Ventura Unified School District Ventura High School Modernization

DRAWING TITLE:
BUILDING "T" EXISTING
ROOF FRAMING PLAN

AS REVISED BY CHANGE ORDER #19
APPROVED WORK IN THIS CHANGE
ORDER SHOWN HIGHLIGHTED
YELLOW.

DETAILS

B1 GUSSETT PLATE AT TRUSS
REF. SCALE: FULL

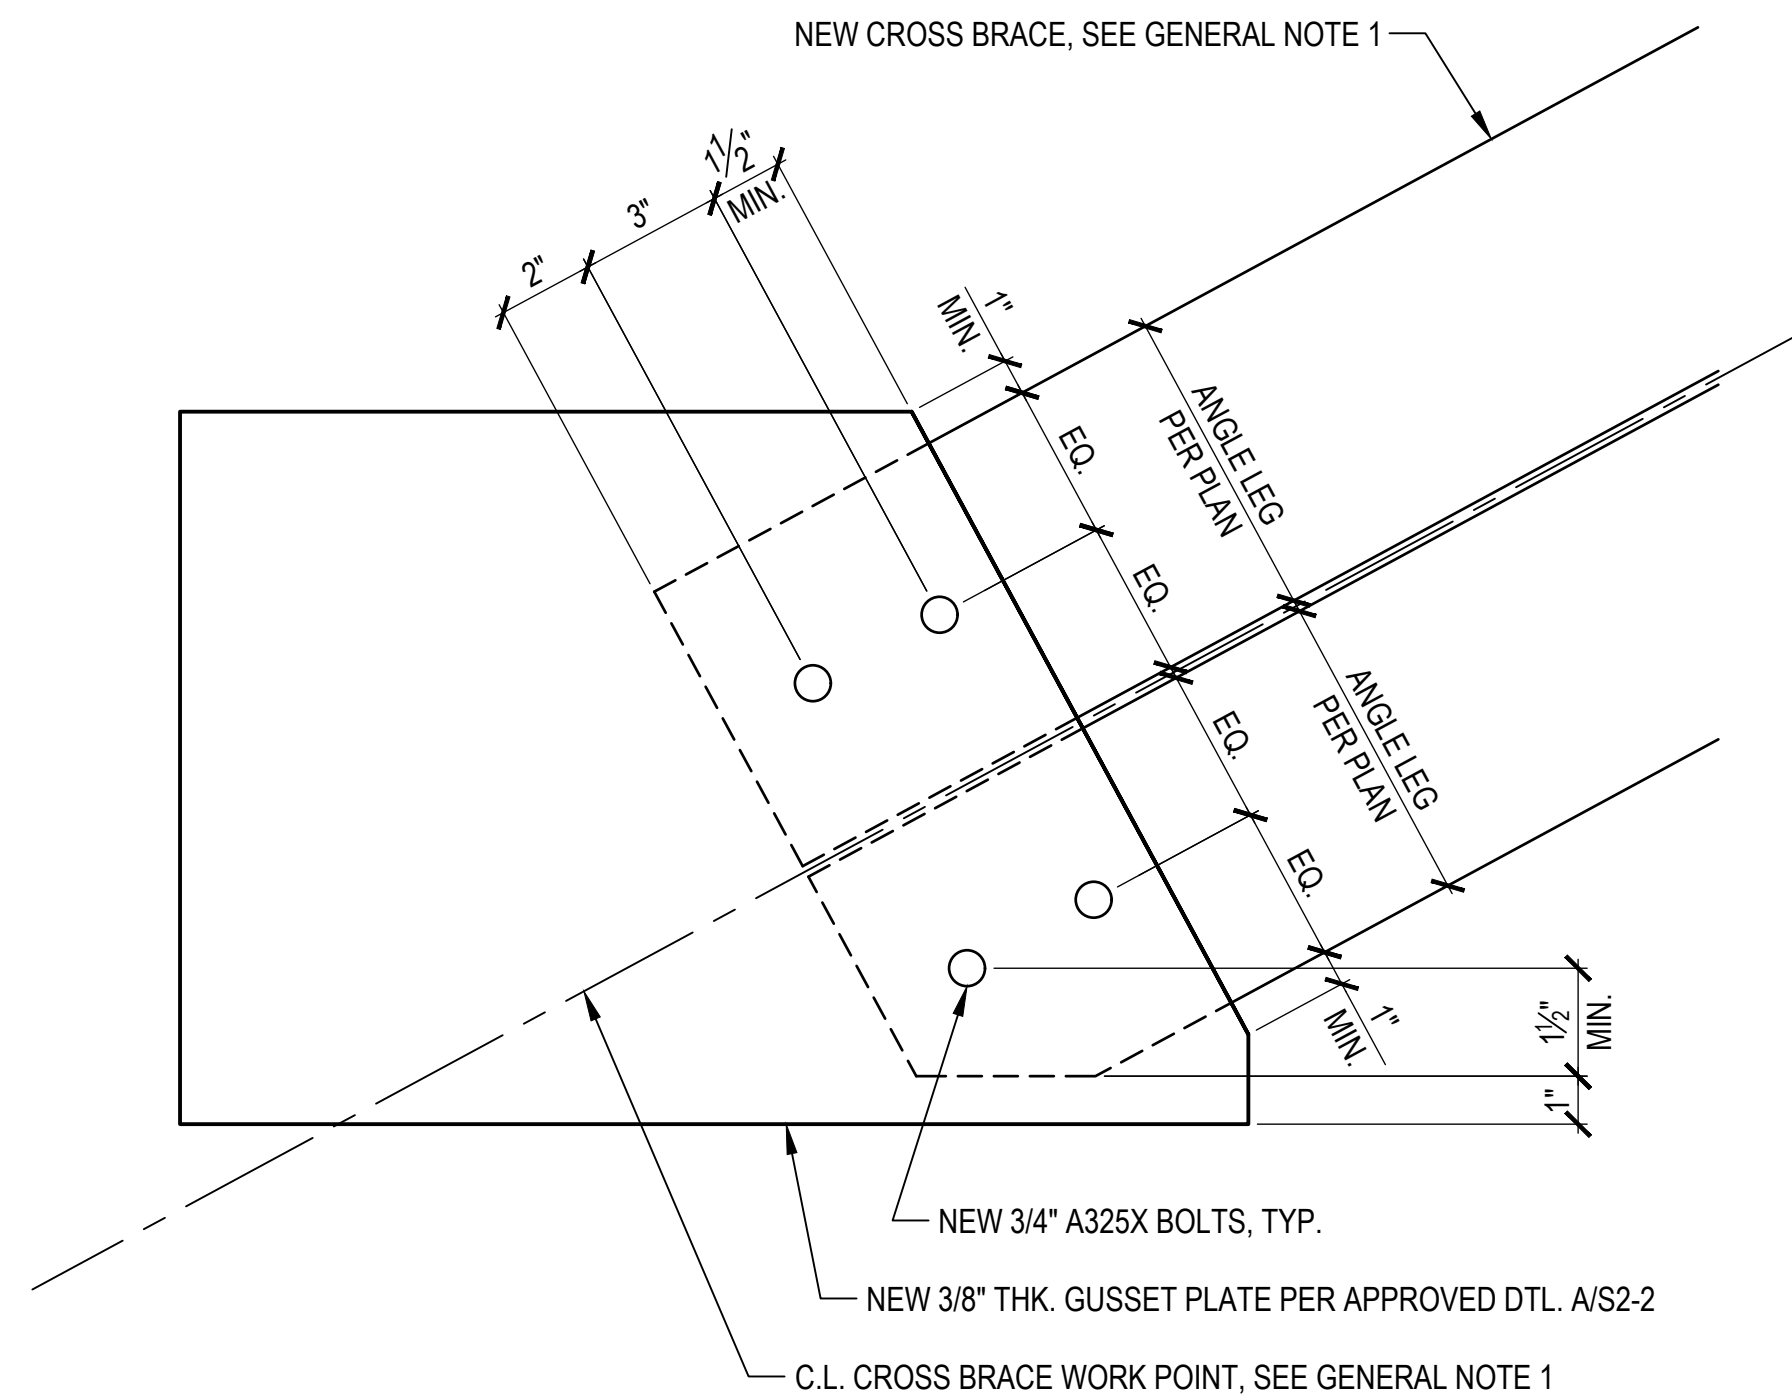
- GENERAL NOTE**
1. NEW CROSS BRACE, SEE APPROVED SHEET ST-1 FOR CROSS BRACE AND SEE APPROVED DTL. A/S2.2 FOR CROSS BRACE BOLTED ATTACHMENT TO GUSSET PLATE

C2 PARTIAL DEMOLITION FROM BELOW
REF. SCALE: 3" = 1'-0"

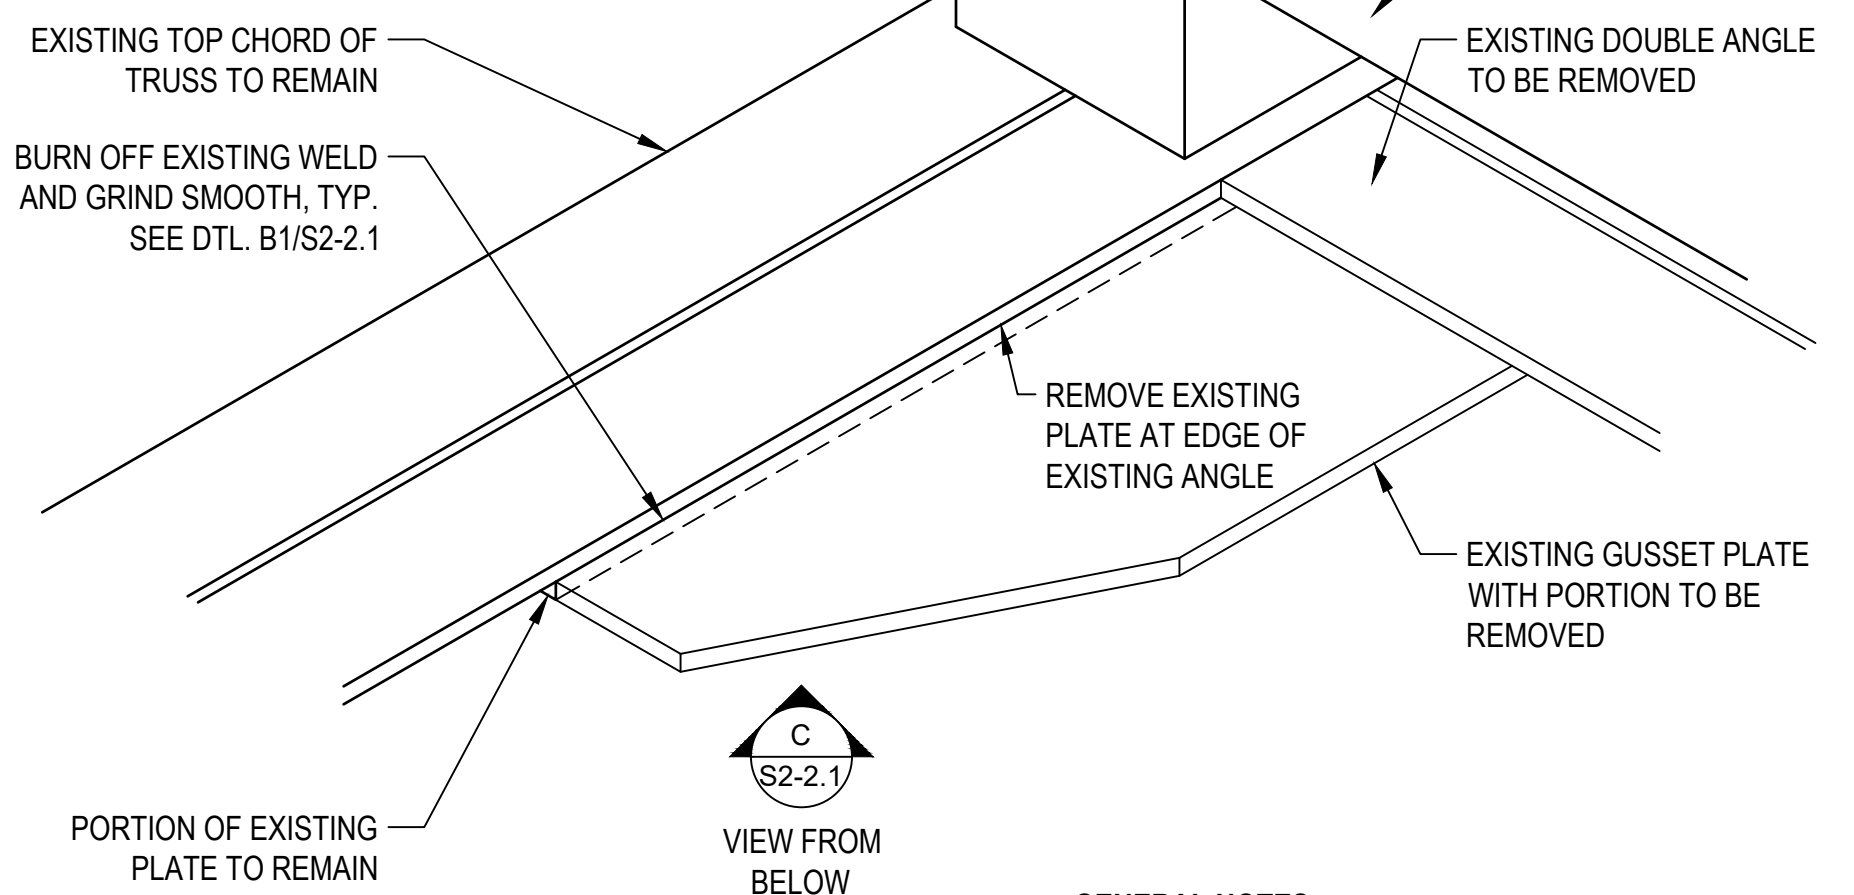
- GENERAL NOTES**
1. EXISTING CROSS BRACE NOT SHOWN FOR CLARITY - CROSS BRACE TO BE REMOVED
 2. SEE NEW DTL. C/S2-2.1 & C1/S2-2.1 FOR ADDITIONAL INFO NOT SHOWN HERE

C1 PARTIAL DEMOLITION
REF. SCALE: 3" = 1'-0"

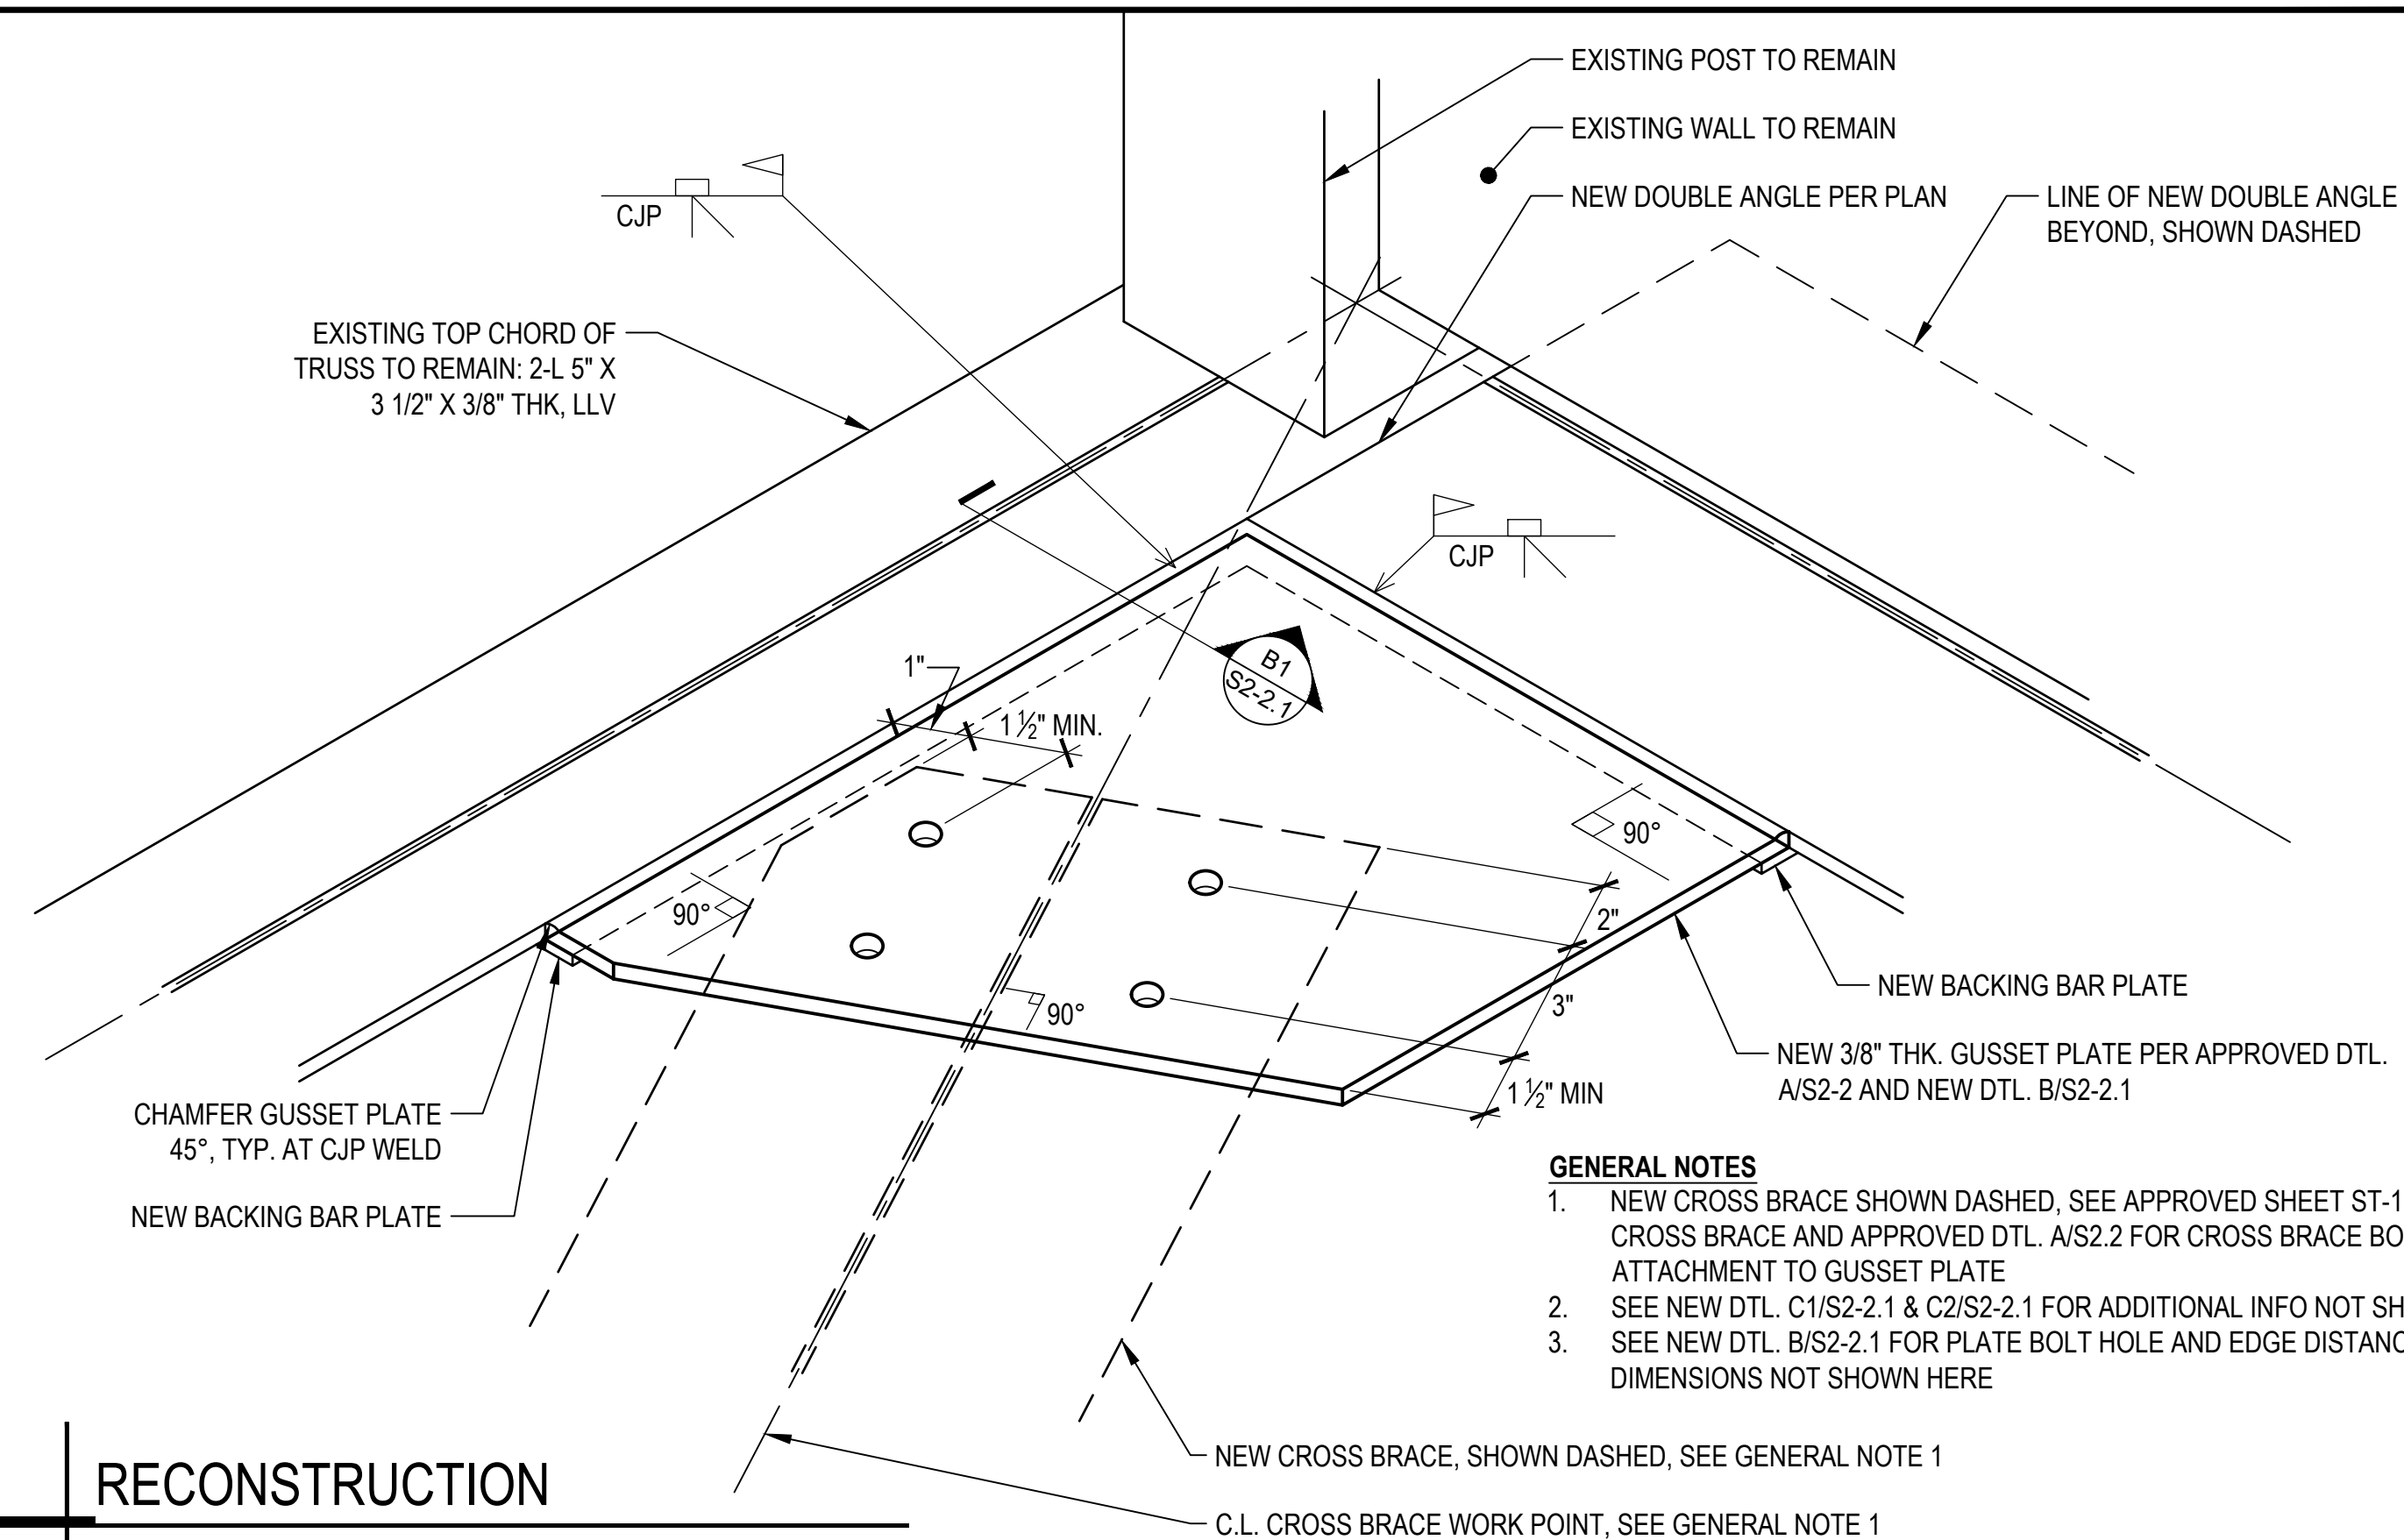
- GENERAL NOTES**
1. EXISTING CROSS BRACE NOT SHOWN FOR CLARITY - CROSS BRACE TO BE REMOVED
 2. SEE NEW DTL. C/S2-2.1 & C2/S2-2.1 FOR ADDITIONAL INFO NOT SHOWN HERE
